APPLICATION FOR
CONSTRUCTION OF
PAVED
SIDEWALK/DRIVEWAY

Application No. 11251

Address: 1132 Beverly st New Bedford MA
street city state zip code

Resurface Driveway

*1132 Beverly St.
Donald Clattenburg
P134
L12*

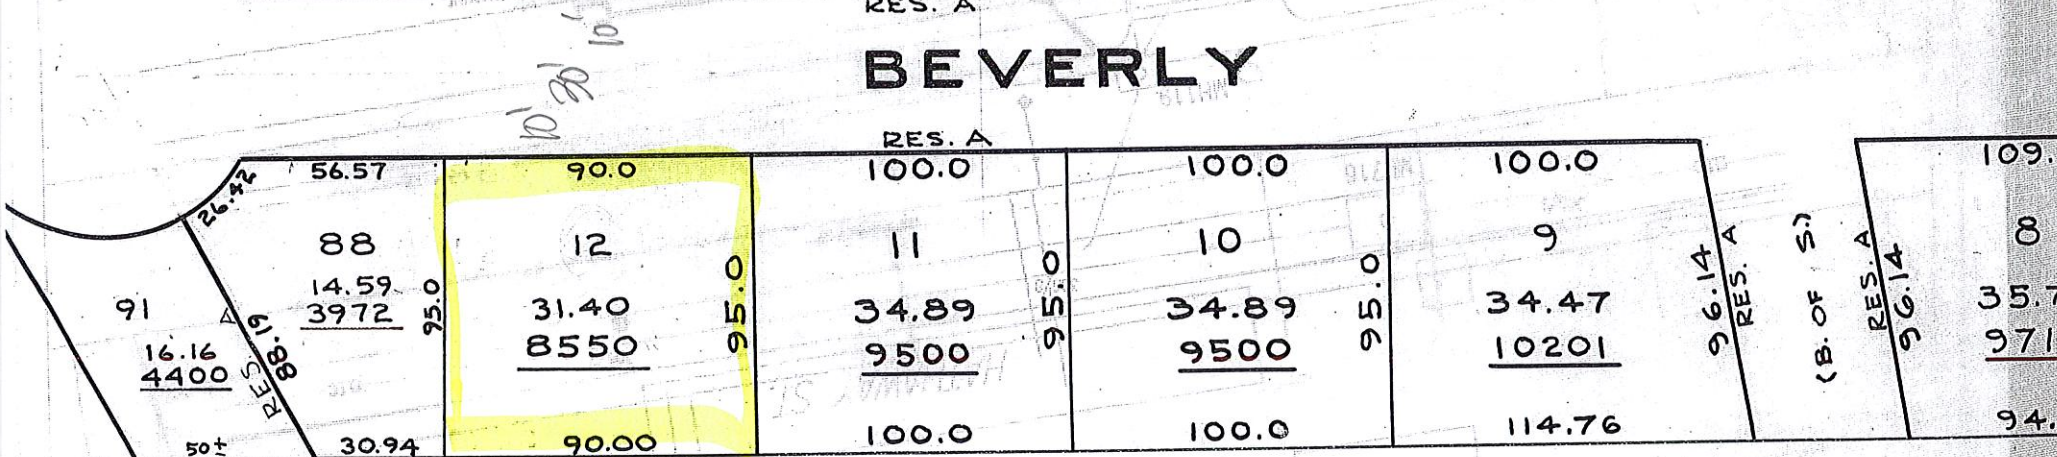
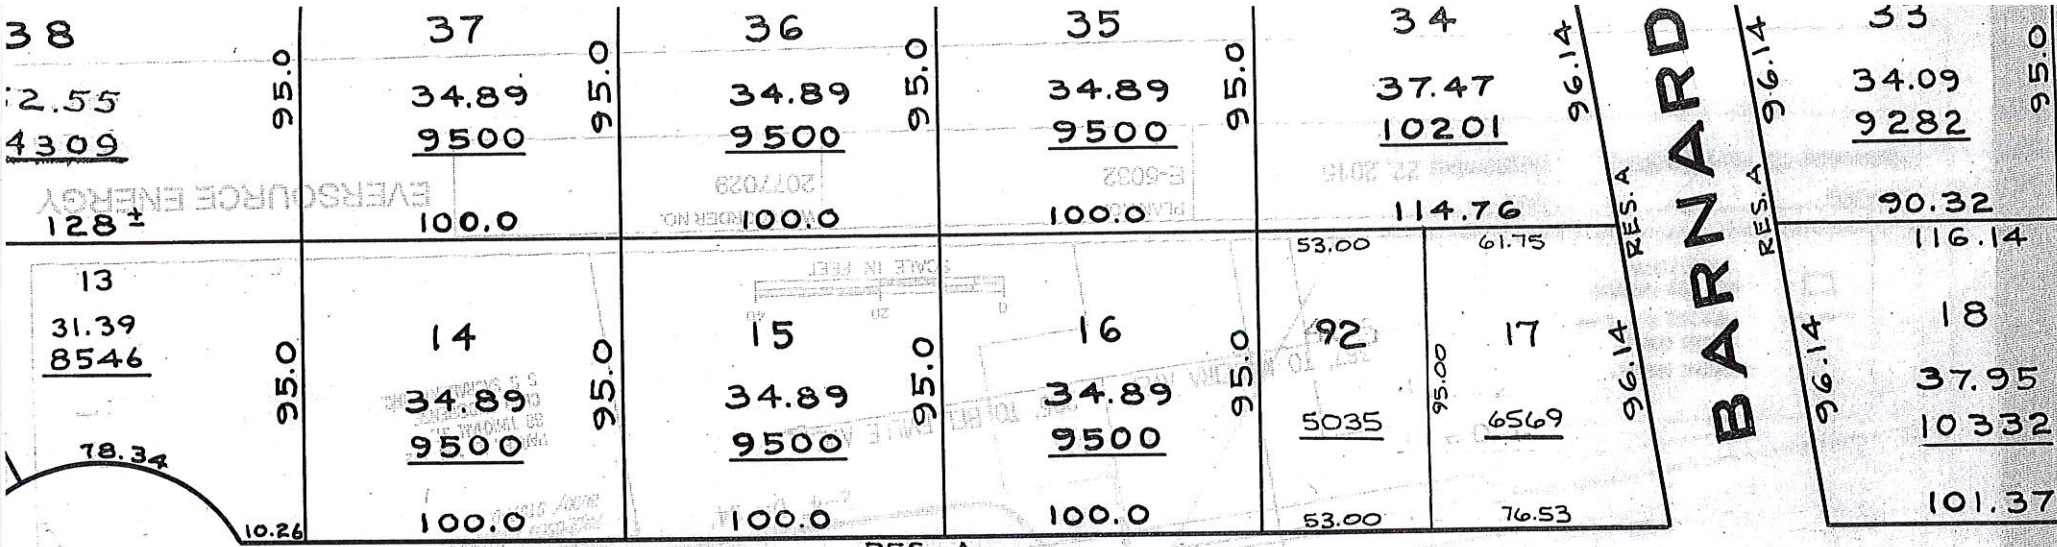
**Existing 13'x10' Hot mix Asphalt brow
No Curb
Install 13'x10' Hot mix Asphalt brow*
